PLANS AND DOCUMENTS referred to in the PDA DEVELOPMENT APPROVAL

REV	DATE	DESIGN	DRAWN	REVISION DETAILS		DRAWN	STATUS		SCALE	CLIENT	PROJECT NAME	DRAWING TITLE		
A	27.01.26	BC	JB	ORIGINAL ISSUE			ISSUED FOR APPROVAL		1:250	5 0 5 10	A1	PEET FLAGSTONE CITY Pty. Ltd.	FLAGSTONE - STAGE 10E-OVERFLOW	ROADWORKS AND DRAINAGE LAYOUT PLAN
B	06.02.26	BC	JR	DRIVEWAY RELOCATION, 3 CARPARKS REMOVED AND GENERAL DRAFTING AMENDMENTS					1:500		A3			
									1:5000	100 50 0 100 200	A1			
									1:10000		A3			
					DESIGN	APPROVED DANIEL COLLINS RPEQ 18631		ASSOCIATED CONSULTANT RPS PHONE: (07) 3437 2000	FLAGSTONIAN DRIVE FLAGSTONE	PROJECT No. 25-0258	DRAWING No. 0820	REVISION B		
					FOR AND ON BEHALF OF COLLIERS INTERNATIONAL ENGINEERING & DESIGN PTY LTD

AMENDED IN RED

REV	DATE	DESIGN	DRAWN	REVISION DETAILS		DRAWN	STATUS		SCALE	CLIENT	PROJECT NAME	DRAWING TITLE		
A	27.01.26	BC	JB	ORIGINAL ISSUE			ISSUED FOR APPROVAL		1:250 5 0 5 10 A1	PEET FLAGSTONE CITY Pty. Ltd.	FLAGSTONE - STAGE 10E-OVERFLOW	SURVEY SETOUT LAYOUT PLAN		
B	06.02.26	BC	JR	DRIVEWAY RELOCATION, 3 CARPARKS REMOVED AND GENERAL DRAFTING AMENDMENTS					1:500 100 50 0 100 200 A1					
									1:10000					
						DESIGN	APPROVED DANIEL

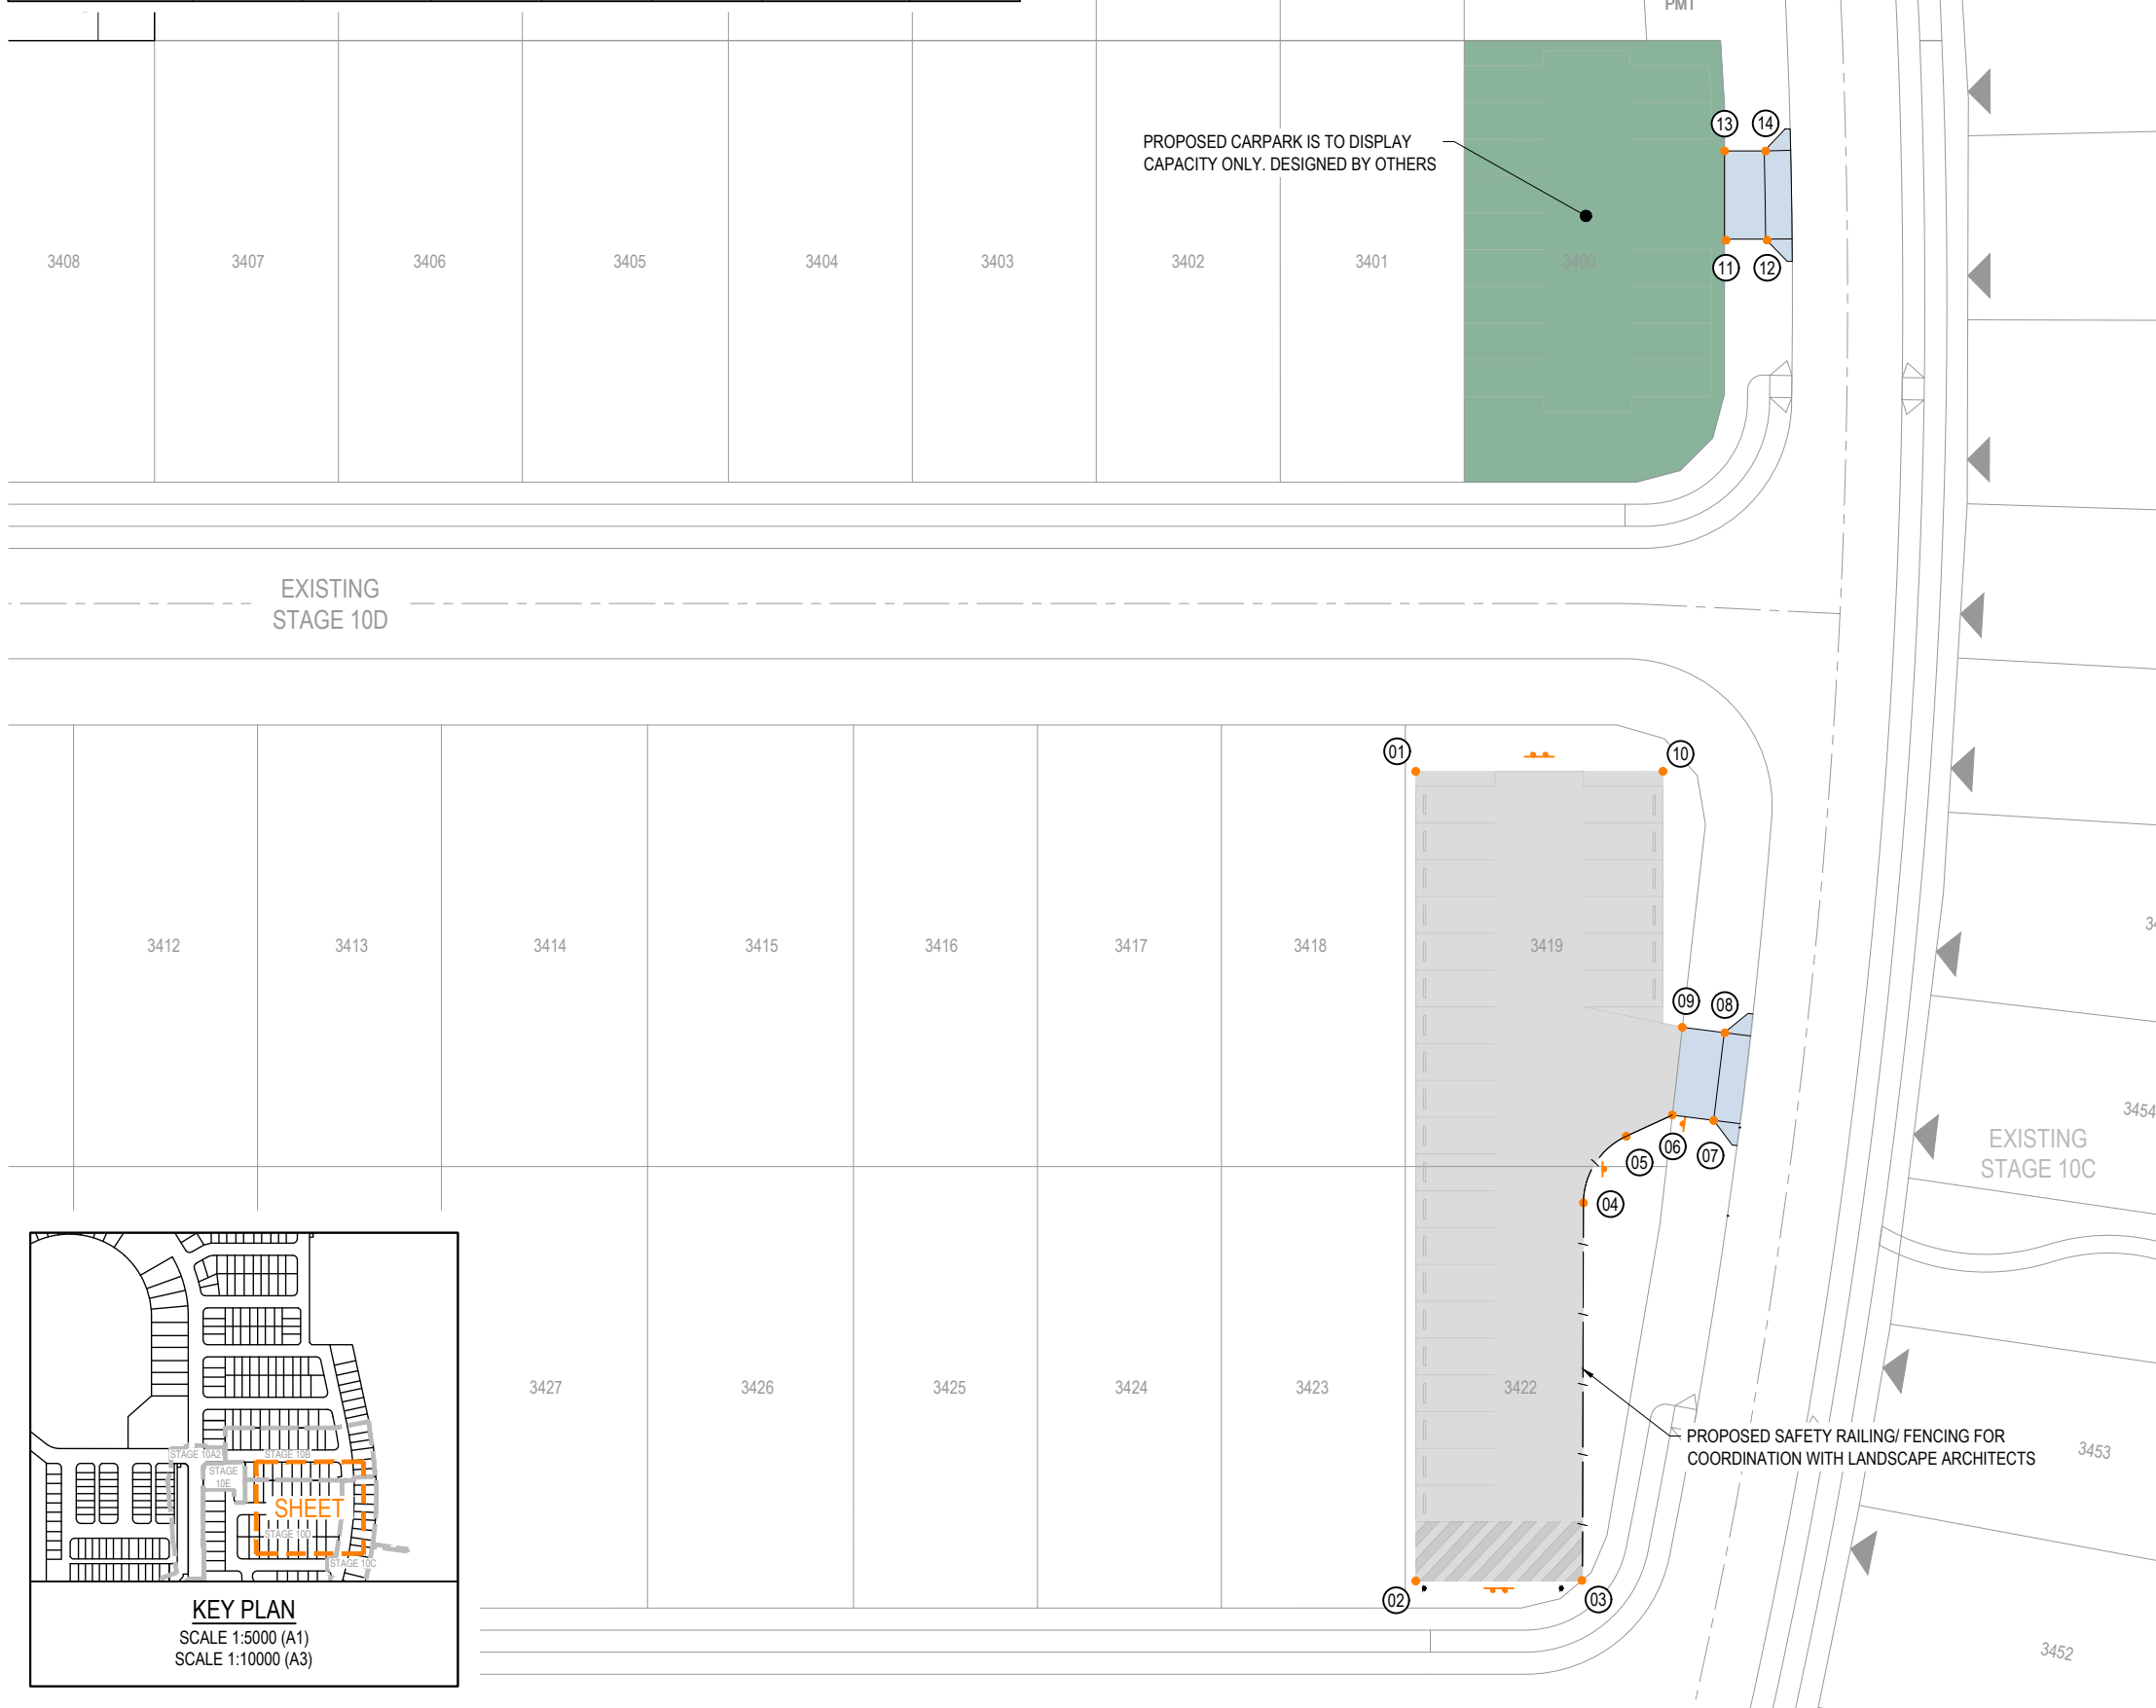
Ensure the temporary car park is drained to the existing gully pits to prevent any uncontrolled storm water run off onto adjoining lots
